City of Lakewood
Board of Building Standards •
Architectural Board of Review •
Sign Review Board

MINUTES
BOARD OF BUILDING STANDARDS/
ARCHITECTURAL BOARD OF REVIEW/SIGN REVIEW
REVIEW MEETING
CITY OF LAKEWOOD
12650 DETROIT AVENUE
AUDITORIUM
JULY 10, 2025
5:30 P.M.
MEETING RECORDED
<https://www.lakewoodoh.gov/videos-2/>

WALL SECTION THRU FRONT ELEVATION
SCALE: 3/4" = 1'-0"

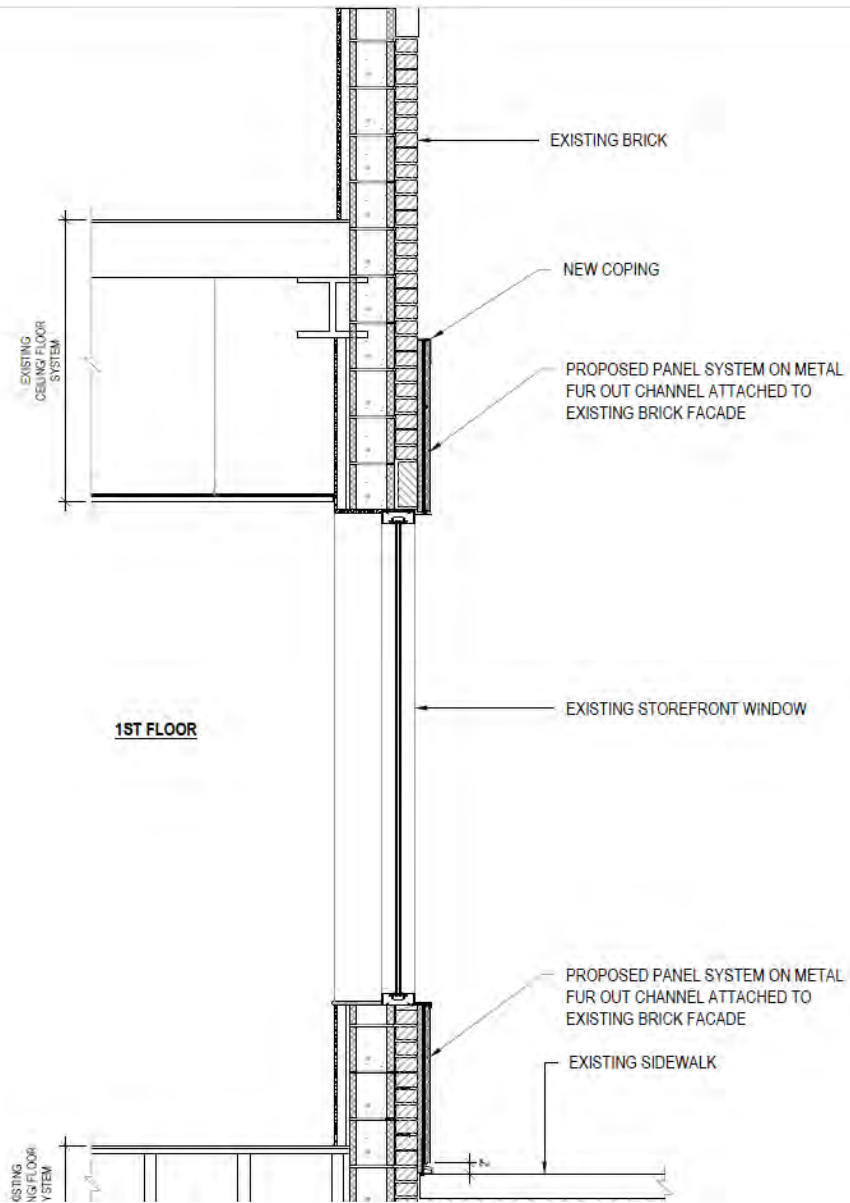
Michael Daso, Daso Properties, applicant, and Burt Wirtz, contractor, were present to explain the request. Discussion ensued about the design complementing the historic nature of the current structure, differing

material colors, the awnings heights, the white Nichiha wrapping into the front door, painting the previously painted brick, retaining the existing chain link fence, ramps, traffic flow within the parking lot. Public communication received by staff prior to the meeting was recognized (made part of record). Public comment was closed as no one addressed the item. There were no other questions from the members.

2. Item #6 16024 Madison: exterior renovation The storefront design should take its cues from the historic second story. Instead, the architectural details and vocabulary of the historic building are ignored with a storefront design that looks like it belongs in Westlake. The colors, materials and material sizes are inappropriate and should not be approved.

6. Docket 06-49-25: 16024 Madison Ave. Neighborhood Pediatrics
 - We are excited to see improvements proposed for the former human services center.
 - We also appreciate the first-floor massing and addressing the entrance(s).

- However, we question if the storefront design should take its cues from the historic second story.
 - The colors, materials and material sizes do not currently relate to the existing building.

- Only brick that is already painted will be repainted.
- Clarify there will be a vertical metal channel or some type of trim to provide a visual break between the two Nichiha materials on the facade.

ELEVATION - "A" WALL

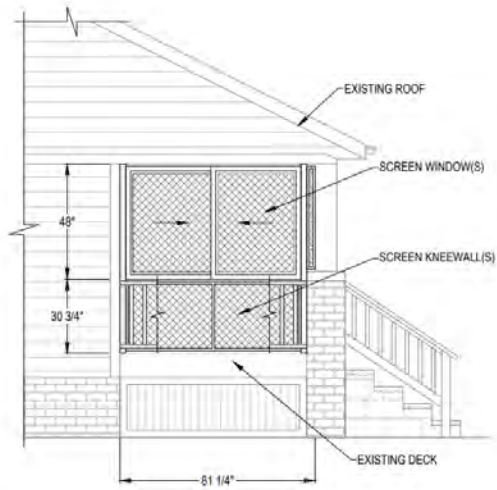
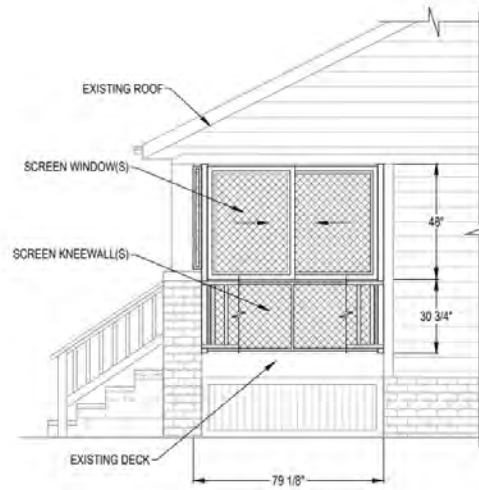
Jeff Leonard, on behalf of the applicant, was present to explain the request. Discussion started about placement of the screening in relationship to the existing railings, the existing columns, dimensions of the doorway, panel, and screening. Administrative staff had no comments. Public comment was closed as no one addressed the item. The members had no additional questions or comments.

- Provide photo of house (existing)
- Provide cut sheet/sample of screen material
- Provide material/information on infill panel on missing column
- Clarify if railing is in front of or behind screens

- The screened panels will be set behind the existing railing.

ADDITION PLANS

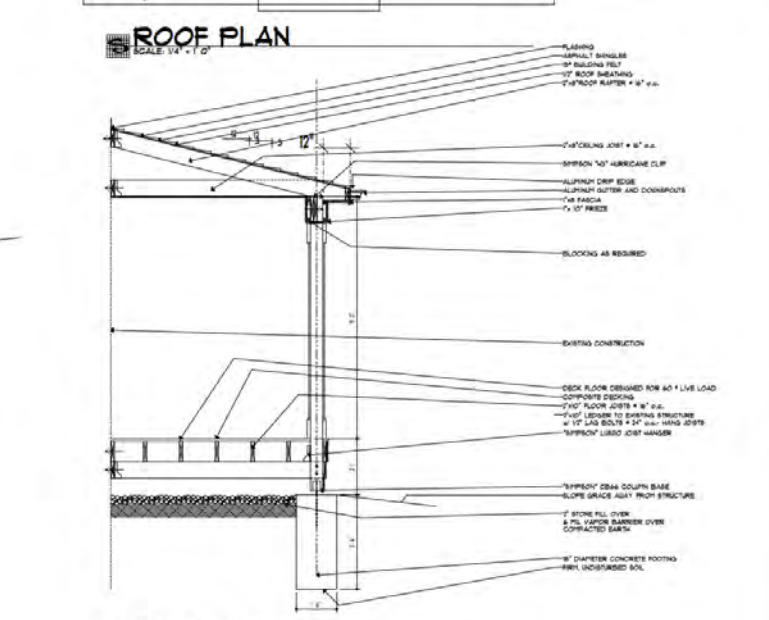
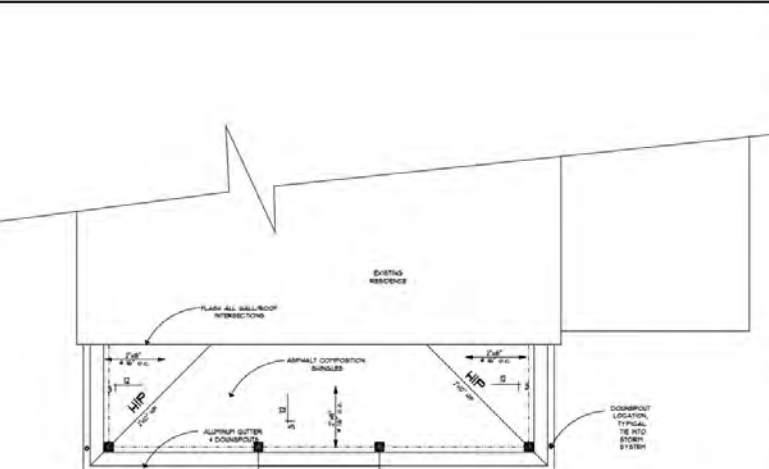
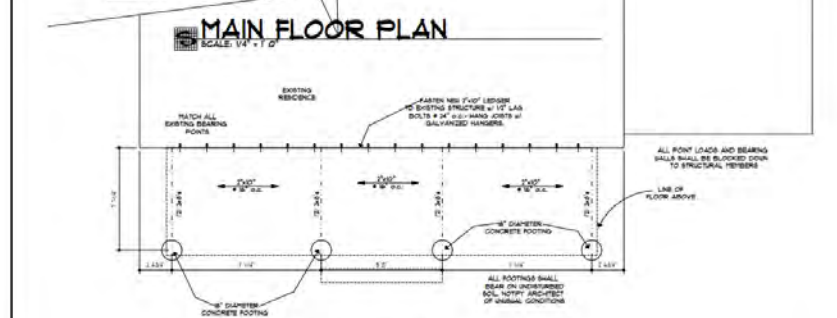
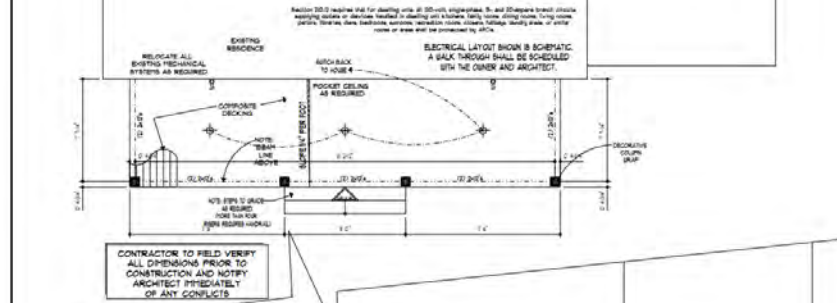
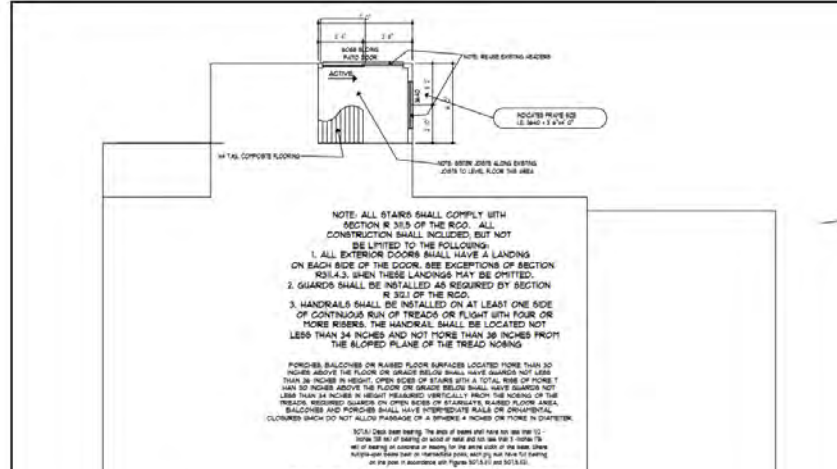
- 32' ft wide x 8' ft deep
- Update elevation to show railing at desired height (railing not required; if desired, railing does not need to be 36" in height)
- Update elevation to show accurate spacing of windows, columns, overhangs, ect.
- Provide cut sheets of lighting, fans, composite skirting, composite decking, roofing, etc.

- The railing height is between 28 and 30 inches and will match the specifications provided.

EXTERIOR ELEVATIONS
 SCALE: 1/4" = 1'-0"
 ALL CONSTRUCTION SHALL COMPLY WITH THE REQUIREMENTS OF THE 2018 RESIDENTIAL CODE OF OHIO.

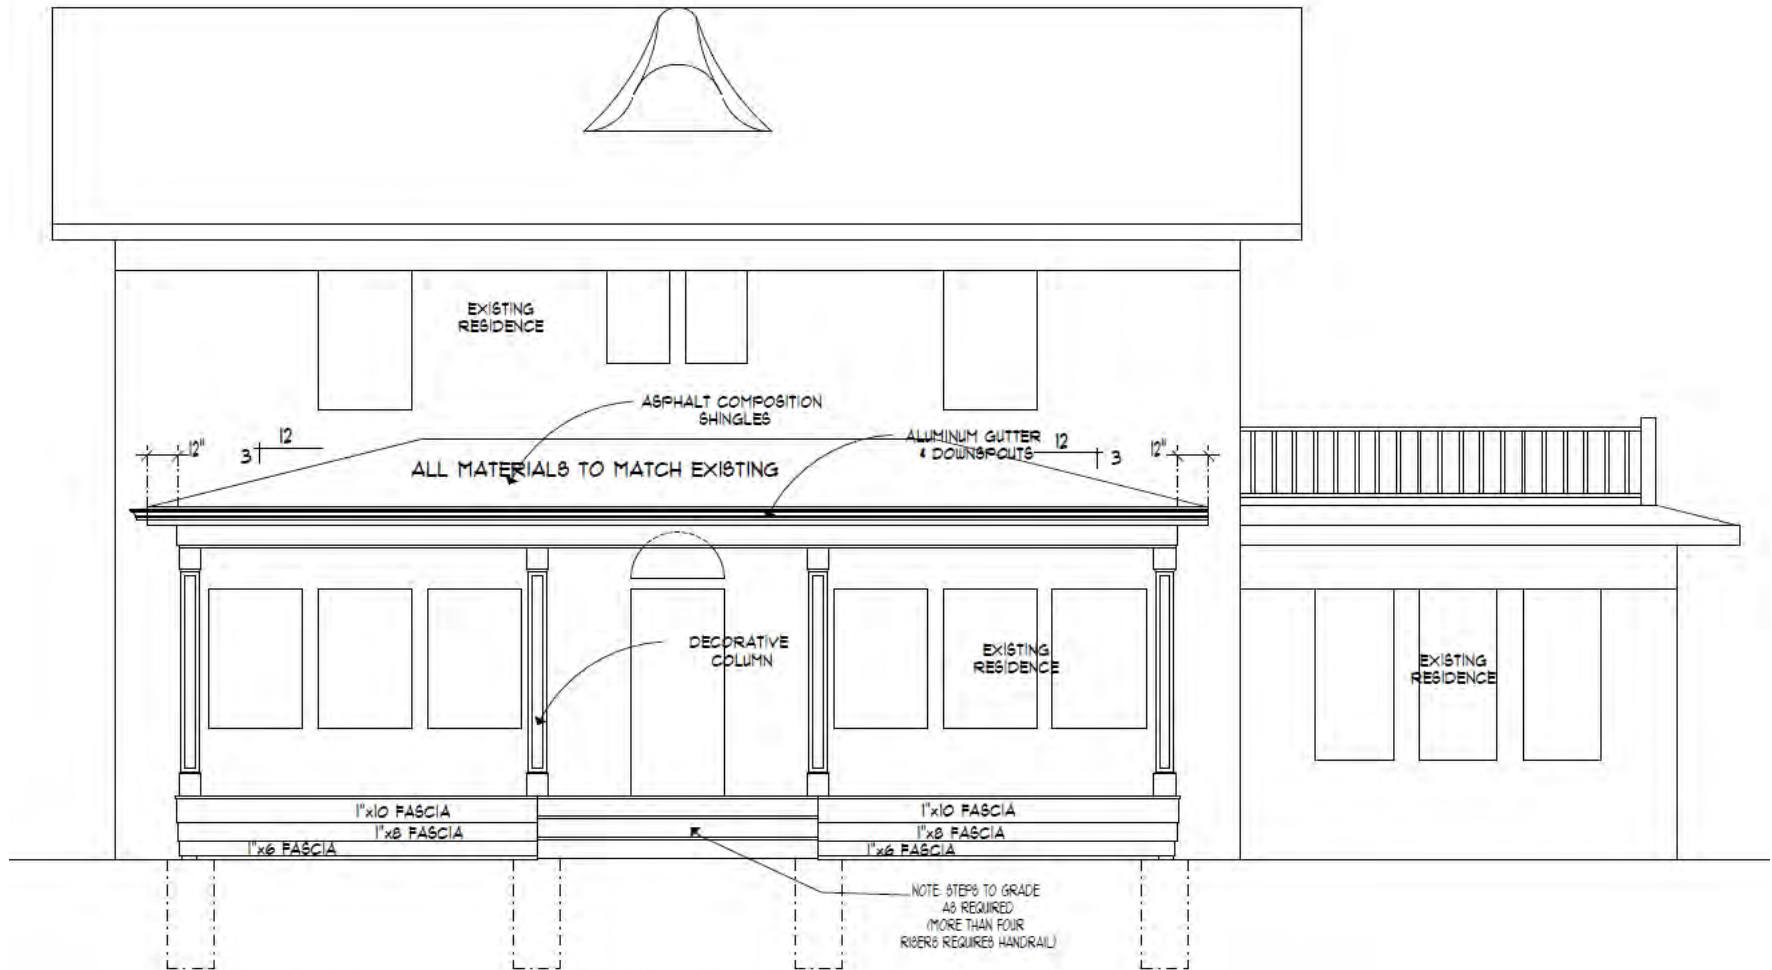
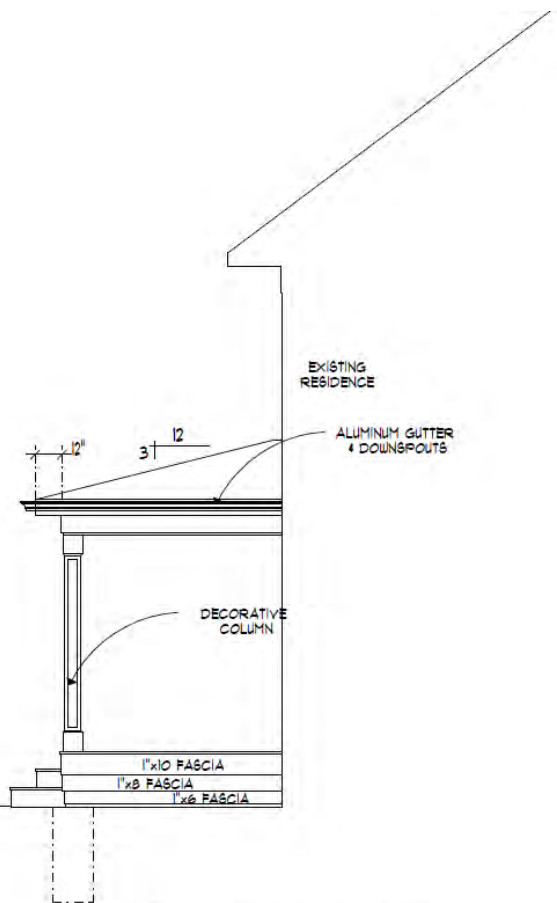
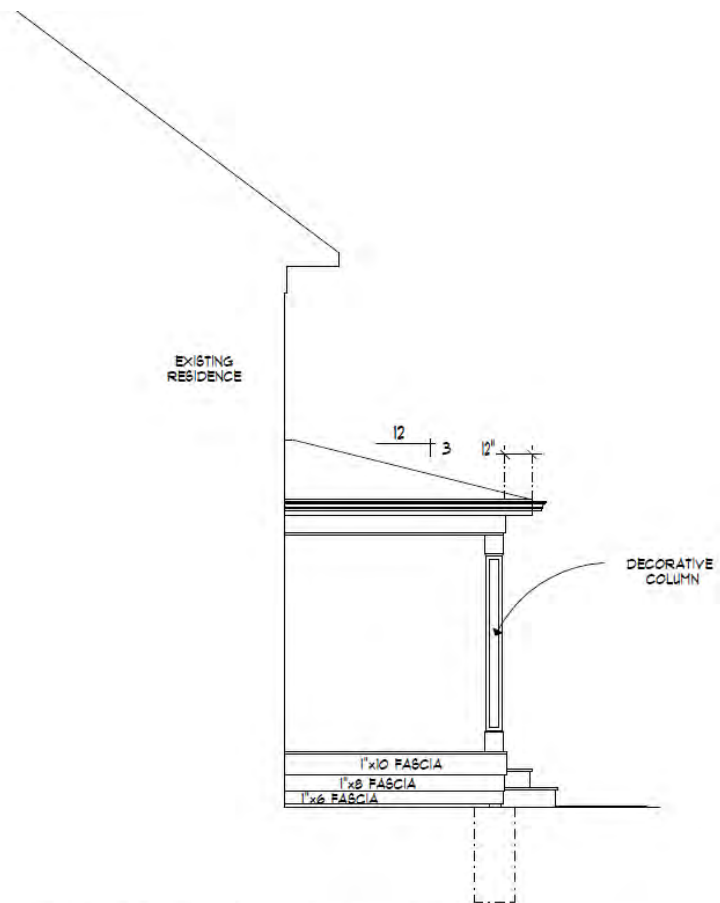
Vincent Valentino, applicant and property owner was present to explain the request. Materials, colors, chimney height, and windows were discussed. The members liked the proposal. Public comment was closed as no one addressed the item.

- Revise section to show overhang of lower roof; section and elevation should match
- Overhang should continue/match that of the rest of the house
- Hardie board should match exposure and paint of existing siding (unless new paint color is chosen)
- If changing house paint color, house and dormer should be the same color
- Building dept. recommends reconfiguring access to seem like 2nd floor of house
- Per applicant:
 - Please see the plan to match existing materials below:
 - Trim Boards 5/4 x 4 1/2 " primed cedar
 - Siding 1/2 x 6" primed cedar
 - Shingles to match
 - Color to match Sherwin Williams color match
 - Vinyl Windows - double insulation, low E
 - Will get the materials we need from Cleveland Lumber who does extensive work in the area and understands the requirements needed to match materials

- The second floor roof line will be maintained along the full length of the dormer to match the existing.
- The new siding will be cedar to match the existing and painted with color to match the existing.
- The windows to match the existing.
